IXOM Chlor- Alkali Plant Repack Facility

*Section 75W
Modification Assessment
(DA 35/98 MOD 5)*

October 2018

Figure 3 | Proposed Repack Facility Layout

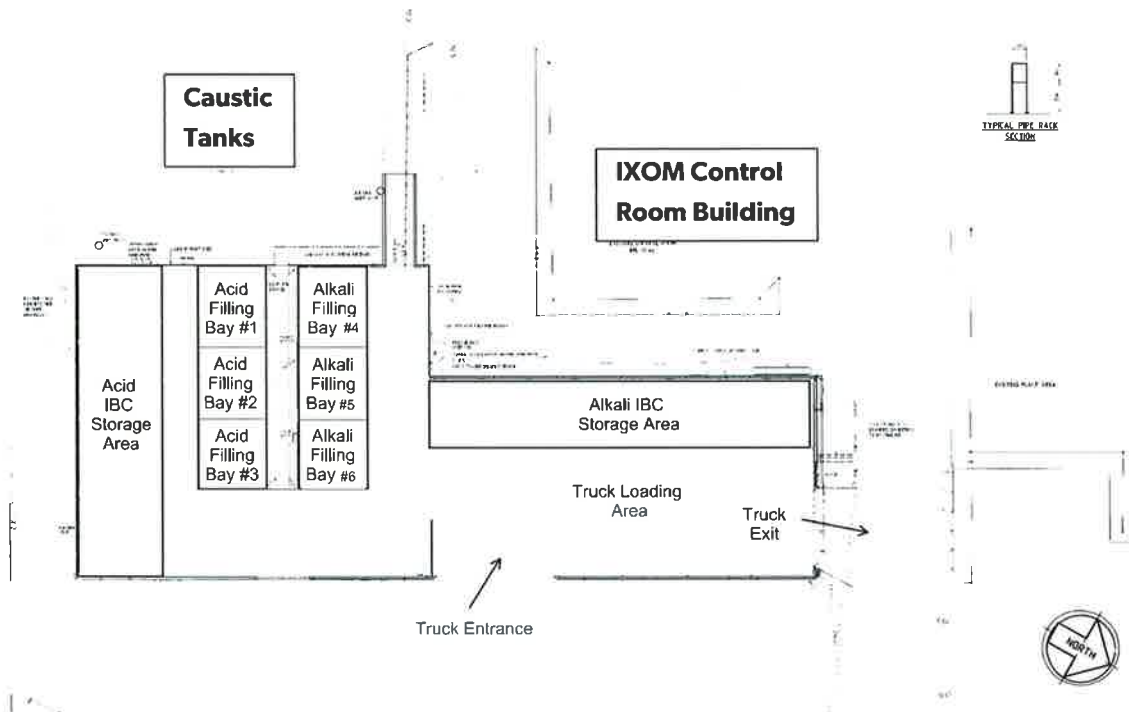
- The Department's assessment identified the footprint provided in the Repack Facility Layout

Figure in the RTS differed from the footprint provided in Figures of the EA

- The Department requested the Proponent to confirm the footprint layout prior to approval
- On 9 October 2018, the Proponent advised the Repack Facility will be built as per the footprint and location as identified in the EA (see **Figure 3**)
